SEB Clarification Questions Regarding APR 1400, DCD Tier 2, Section 3.8 “Design of Category I Structures”

Clarification Question #1 (AI 3-75.1)

Figure 3.8-5 Liner Plate and Anchorage System

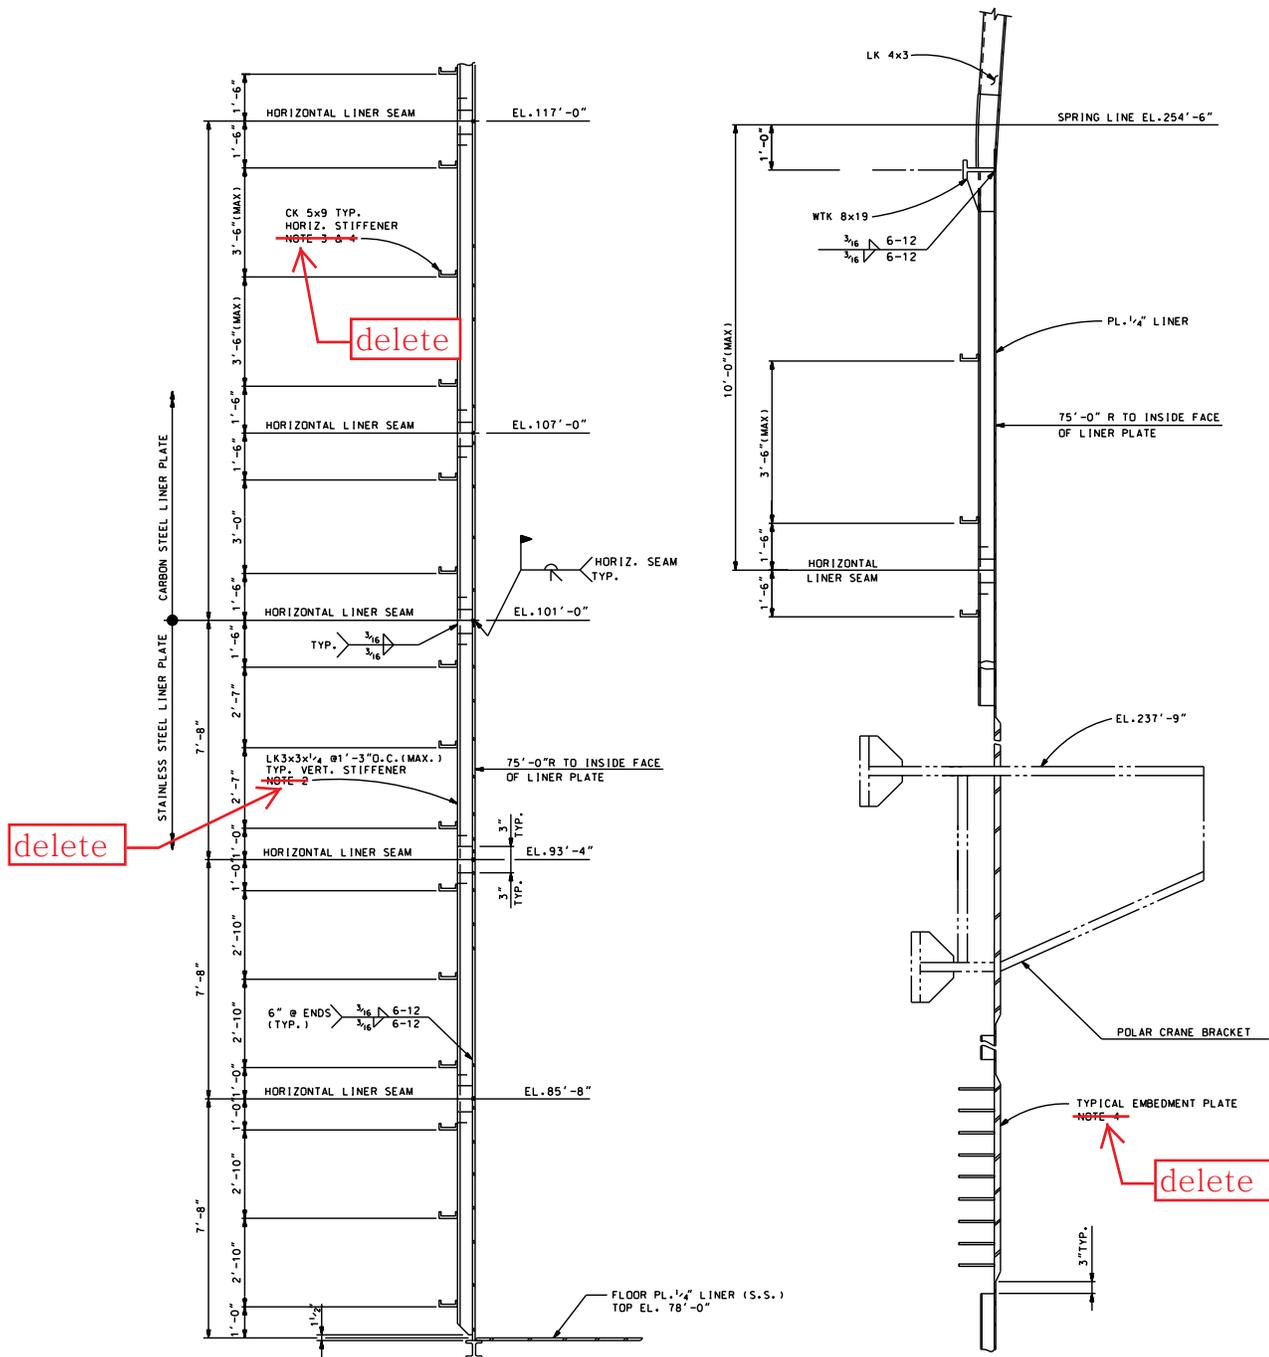
- a) Figure 3.8-5, “Liner Plate and Anchorage System,” on page 3.8-113 of the DCD, mentioned a few notes associated with the type of stiffeners and how the liner plates are typical embedment. However, the staff was not able to locate the descriptions of the notes. The applicant is requested to address where this information is located.
- b) Additionally, since leak-chase channel has been identified as a potential degradation issue according to Information Notice 2014-07, the staff is requesting the applicant to explain how this issue is being addressed in Section 3.8 of the DCD application.

- a) The notes are errata. In general, these notes are provided in detailed design drawings. Figure 3.8-5 will be revised to eliminate the notes.
- b) As discussed during the October 5th and 6th seismic public meeting (ML15275A095), an RAI regarding this issue is to be issued. The issue is to be addressed via KHNP’s RAI response.

DCD Tier 2, Figure 3.8-5 will be revised as indicated in the attachment associated with this response.

Figure 1 RV Support Assembly Detail (1/2)

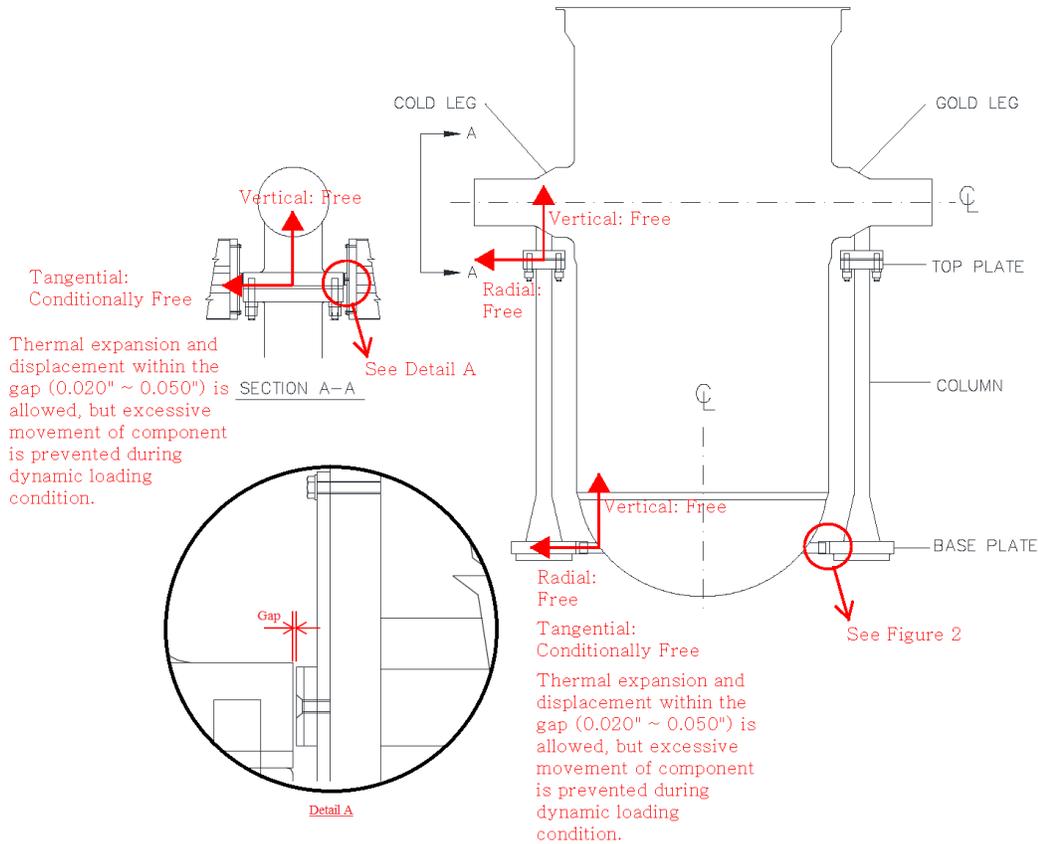
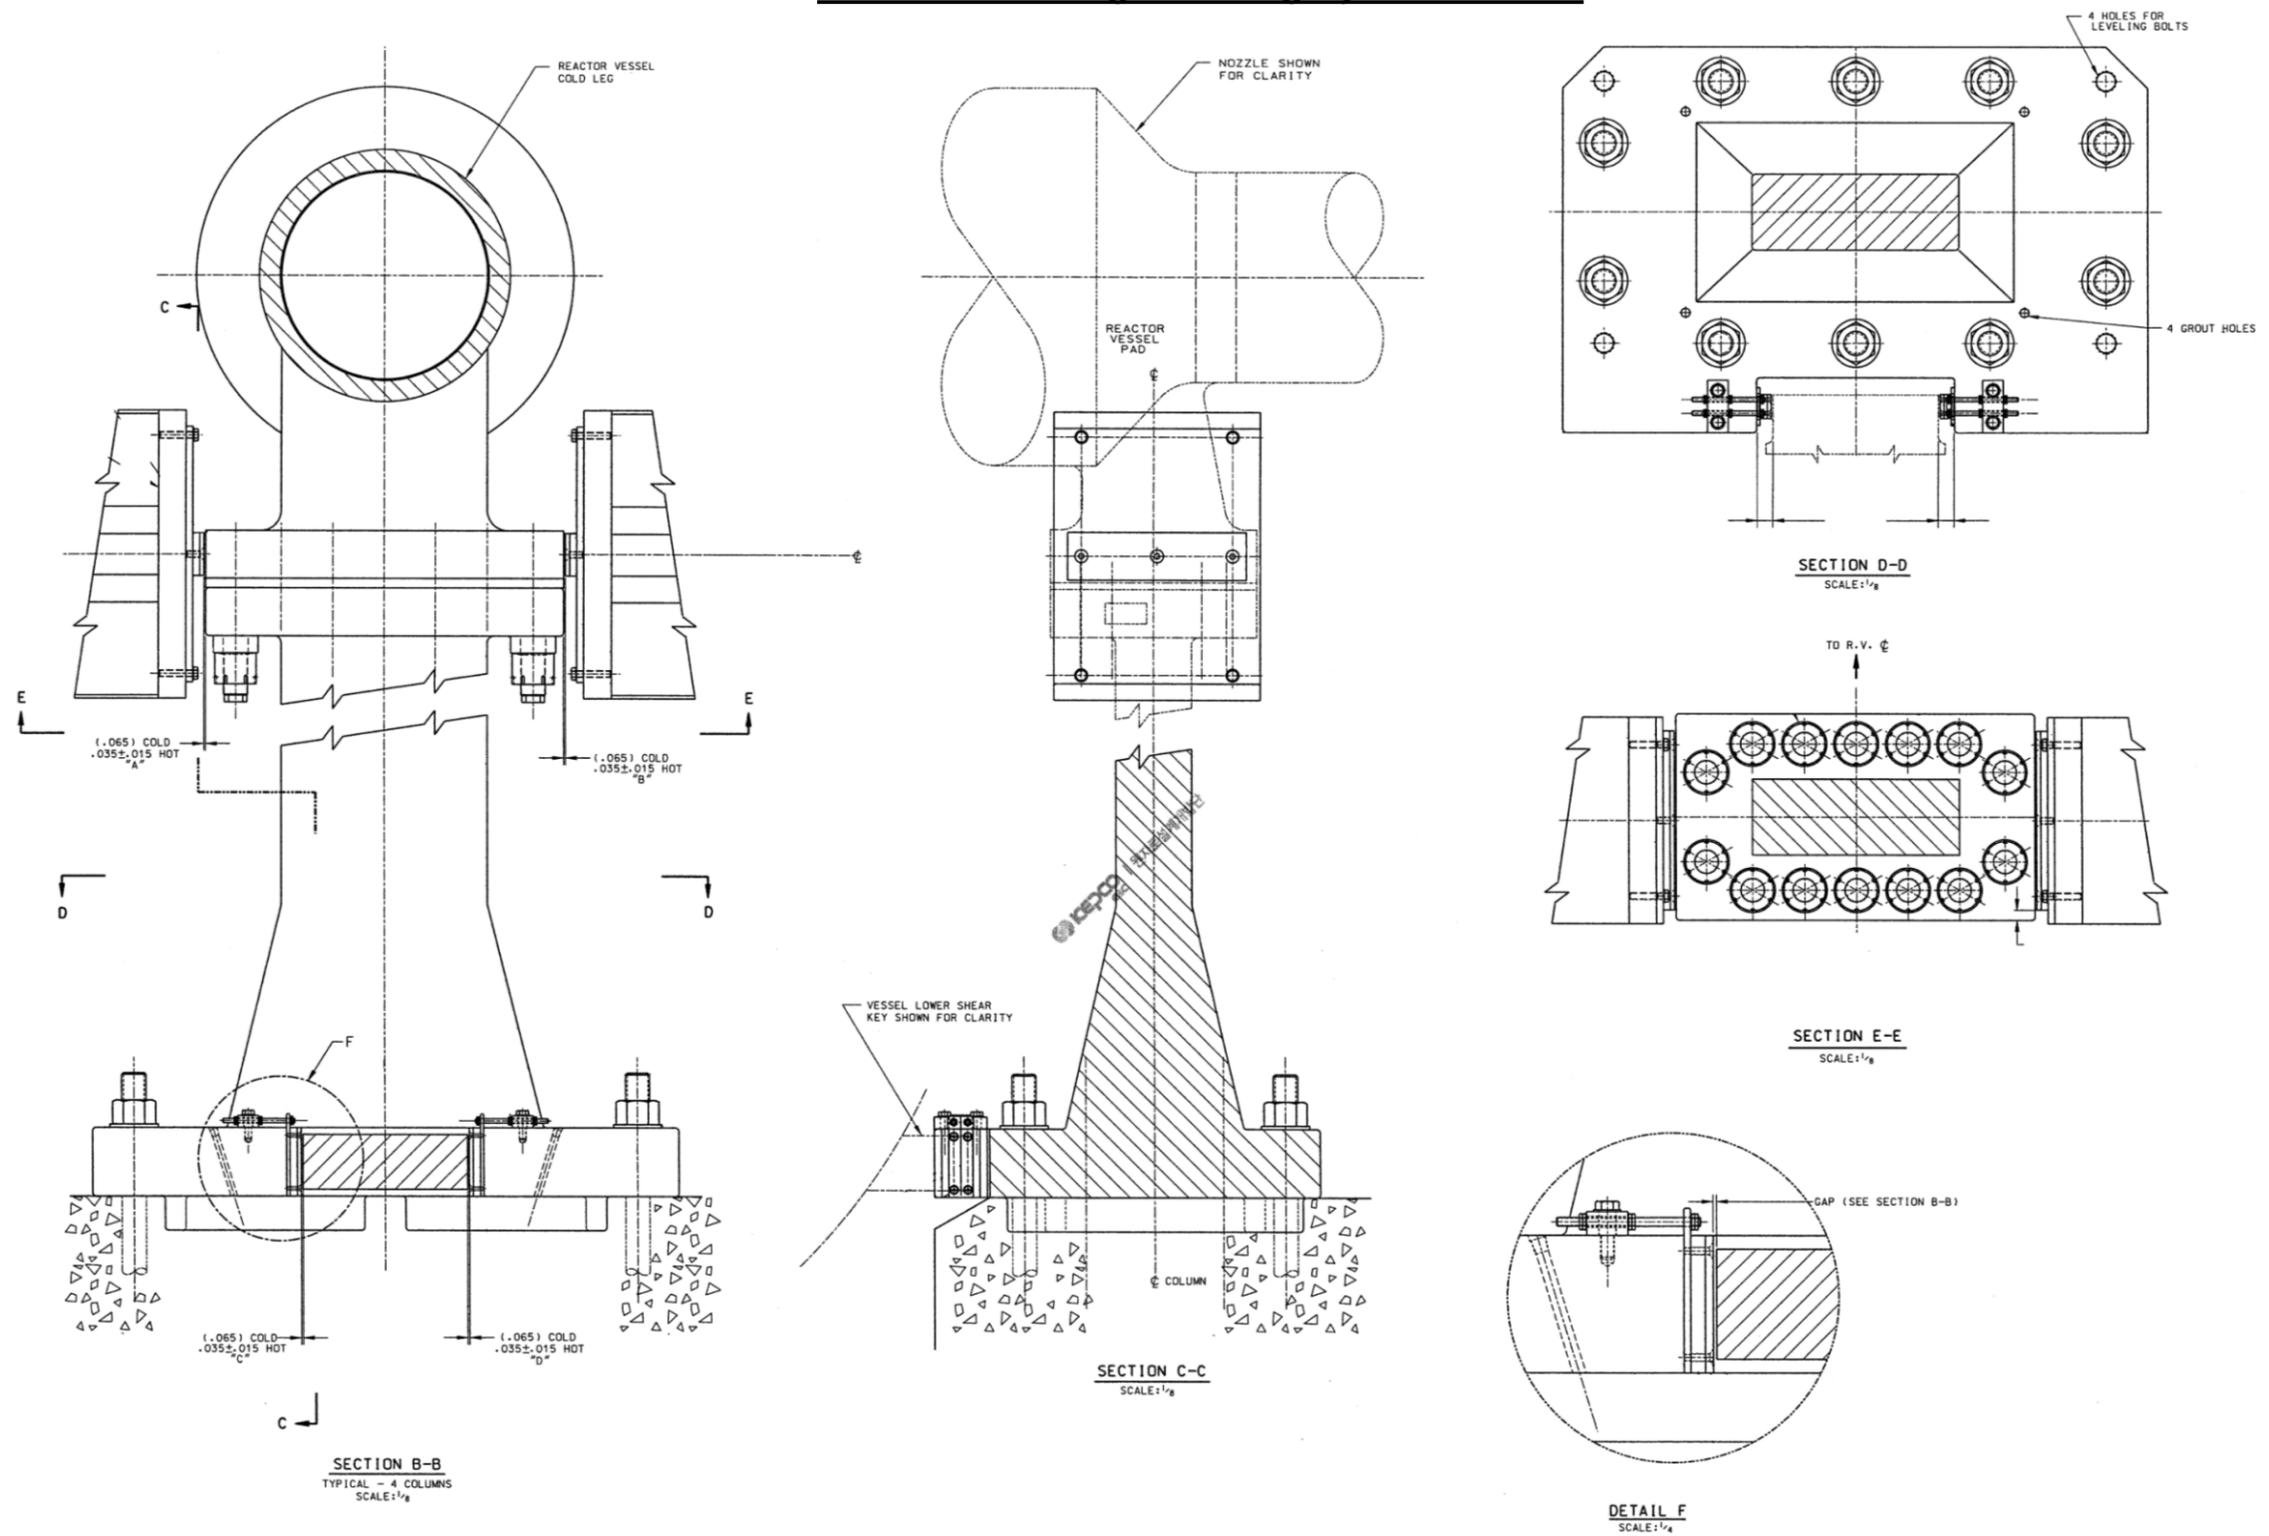
- a) The staff believes that Section B-B of Figure 3.8-15, Sheet 2 of 2, shows what seems to be a sliding plate being used as part of the reactor support system. The applicant is requested to clarify whether a sliding plate is being used, and if so, explain why it’s not described in the DCD.

- b) Since the reactor support column is flexible horizontally, the staff is concerned that large loads can be developed on the support columns and anchor bolts. The applicant is requested to clarify whether the development of these large loads is considered in the analysis and design of the reactor support system including the anchors.

- c) Since DCD Figure 3.8-19 shows the reactor vessel support anchors are close to the edge of the concrete cavity wall ledge and also close to each other, the applicant is requested to clarify whether the edge distance and distance between the anchors were considered in determining the reduced design strength of the anchors.

- a) The RV support is fixed with anchor bolts at the bottom. No sliding plate is used for the RV vertical support system. Section B-B of Figure 3.8-15 shows the lateral support of the RV support to restrain excessive tangential motions for dynamic load conditions. There are small gaps (0.020 ~0.050 in) between the integral column pad and non-integral RV supports attached to the building structures, so that they do not contact each other under normal operating conditions, but restrain excessive lateral movement under dynamic load conditions such as SSE, BLPB, and IRWST discharge events.

The RV Supports are long and slender columns so that they can bend to allow expansion and contraction of the RV in the radial direction, but restrict excessive lateral movement under dynamic loading conditions. They are fixed with anchor bolts at the bottom, restricting movement in all six degrees of freedom. Four (4) sets of upper and lower lateral supports are also engaged with keyway type structures which are fixed to the containment building and RV Support base plate, respectively, in order to restrain excessive tangential movement of the RV during dynamic events such as seismic, BLPB, and IRWST.

The RV can translate and rotate horizontally within the limited displacements and angles as much as allowed by the RV Support column gaps (0.020 ~0.050 in) in the

upper and lower horizontal supports as shown in the figures below. For more information, please refer to DCD Section 5.4.15.2 and Figures 5.1.3-1, 5.1.3-2, and 5.4.15-2.

- b) The RV support system, including anchors, is designed to maintain its structural integrity under all service loading conditions, including SSE and BLPB events, as specified in DCD Subsection 3.9.3.
- c) The short edge distance and the distance between the anchors were considered in accordance with ACI 349, Appendix B.
